STAFF REPORT
Planning

Title: Zoning By-law Amendment Z-23-04, 143 Columbia Inc.,
143 Columbia Street West

Report Number: IPPW2026-037

File: Z-23-04

Figure 3: Reduced tower separation to interior lot lines

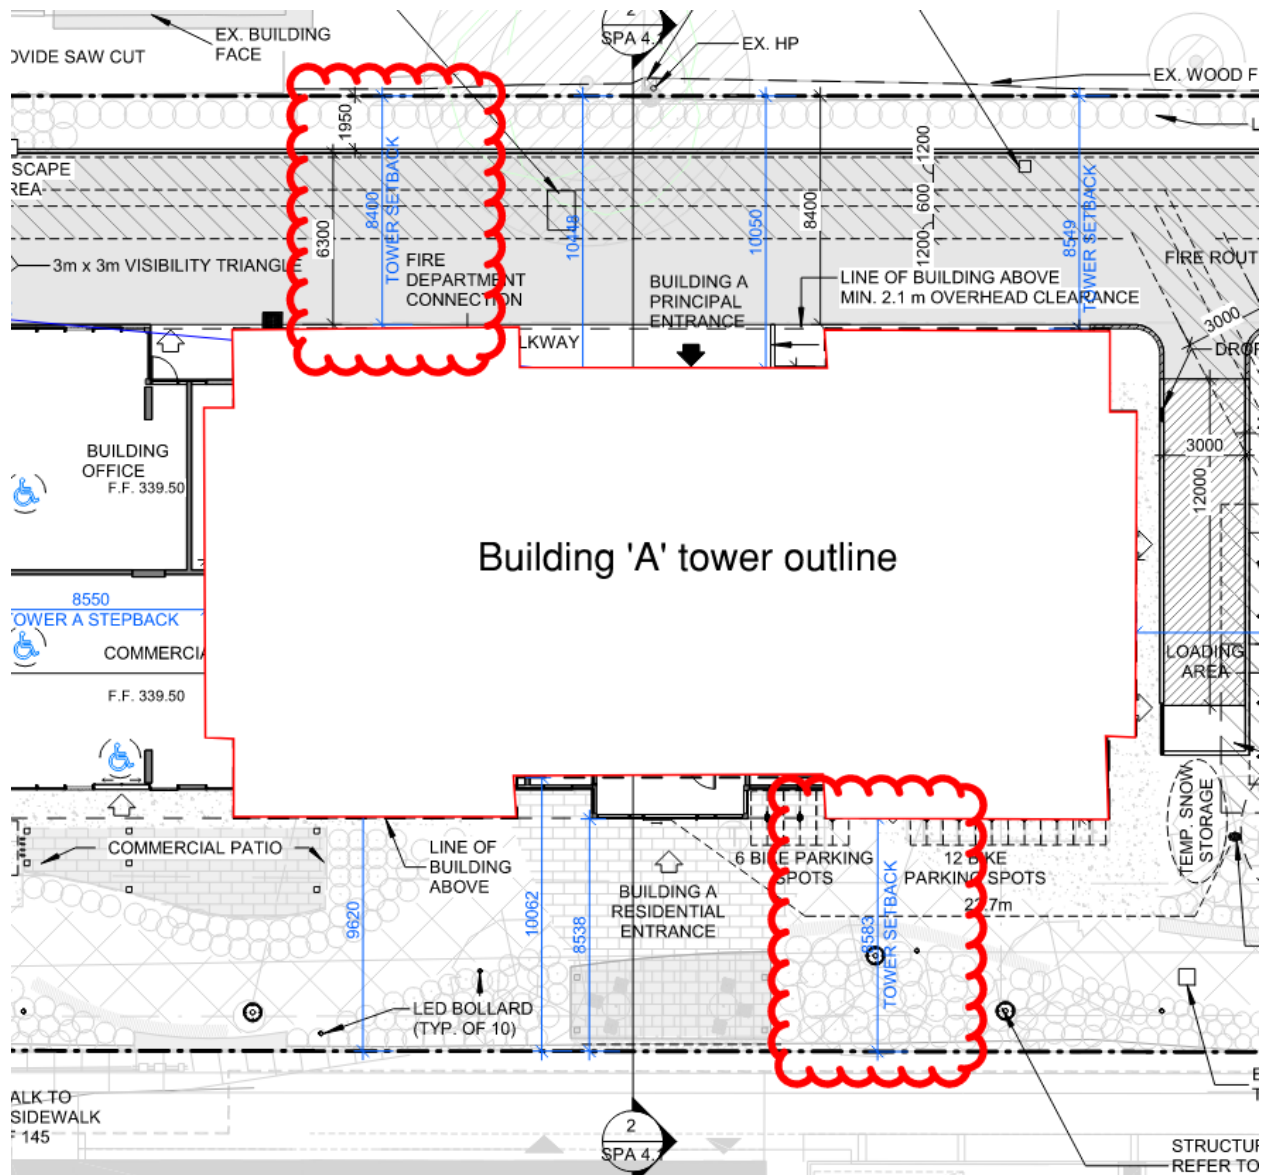
The RN-25 zone requires a minimum tower separation distance of 11.0 metres to an interior lot line, whereas the Applicant is proposing 8.5 metres to the westerly property line and 8.3 metres to the easterly property line, due to the narrow, 'L' shaped configuration of the Site. Through discussions with Planning staff, the Applicant explored shifting the buildings slightly on the lot to reduce the overlap with the existing towers on the adjacent 145 Columbia Street. However, this repositioning of the towers created challenges related to compliance with required noise level thresholds for residential development, due to placement of the existing cooling tower on 145 Columbia Street. As a result, the latest revision of the proposal has returned the towers to the locations initially proposed. Due to the narrow configuration of the Site, as well as the high quality landscaping and pedestrian infrastructure on the westerly portion of the property (the pedestrian promenade), Planning staff have no objection to this requested variance.

Figure 4: Reduced rear yard setback

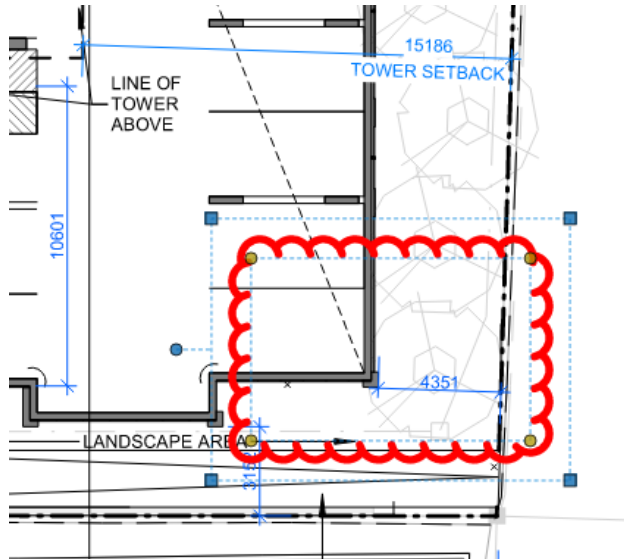
The RN-25 zone requires a minimum rear yard setback of 7.5 metres, whereas the Applicant is requesting a rear yard setback of 4.3 metres for the southern most building (Building C) on the Site. The rear lot line is angled such that the building has a 5.9 metre setback at the south-east corner and then is reduced further to 4.3 metres at the south-west corner.

Staff have no objection to the requested variance, as the podium for this building has been reduced in height to 5.5 metres and the tower setback, at 15 metres, exceeds the

minimum tower separation distance of 11 metres. This, combined with the proposed landscaping along the rear lot line, will reduce the impact on the adjacent property.

Figure 5: Reduced tower stepback above a podium on the two northern most buildings

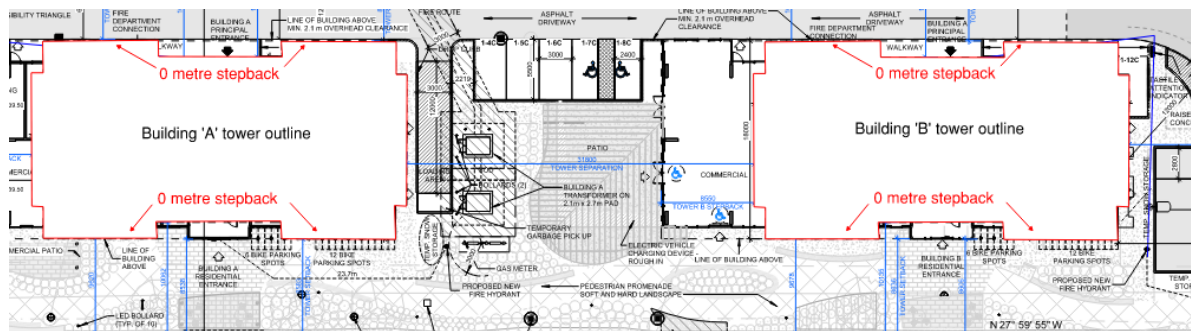
The RN-25 zone requires that towers be stepped back a minimum of 3.0 metres above a podium. The front façade of the northern most towers (Buildings A and B) are exceeding this requirement, being stepped back approximately 8.5 metres from the podiums. However, due to the narrow nature of the Site, the Applicant is proposing a 0 metre stepback for the side and rear façades of these buildings.

Staff have no objection to the reduced the tower stepback requirements. Tower stepbacks are important to breakup the massing of a building and are most vital at the street facing façade to enhance the streetscape and pedestrian realm. The Applicant is exceeding the stepback requirement for the front façade of the two buildings closest to Columbia Street West (Buildings A and B), which will reduce the massing from the street level, maintaining the urban design objective of the requirement. While the podiums could be extended closer to the side lot lines, allowing a tower stepback, the narrow nature of the lot would result in reduced space for vehicle movement (east) and outdoor amenity space (the pedestrian promenade on the west side of the buildings).

Figure 6: Reduced tower stepback for the southern most building

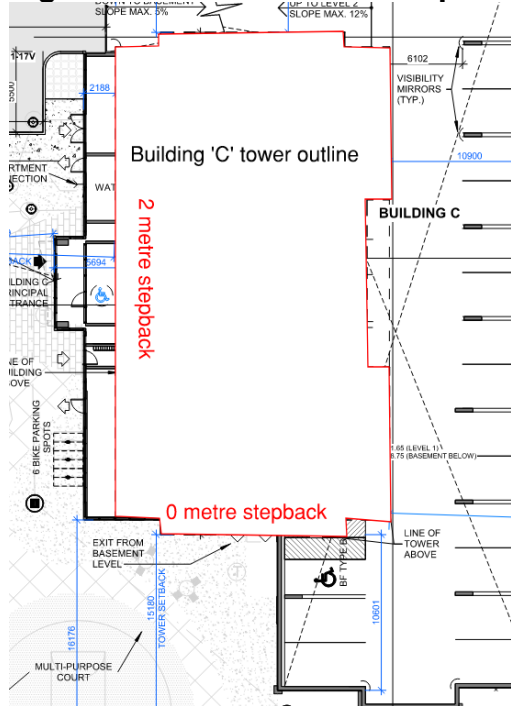
The third building, at the rear of the Site (Building C), is proposed to have a 2.0 metre stepback on the front façade, and a 0 metre stepback for the portion of the west façade directly adjacent to the outdoor amenity area.
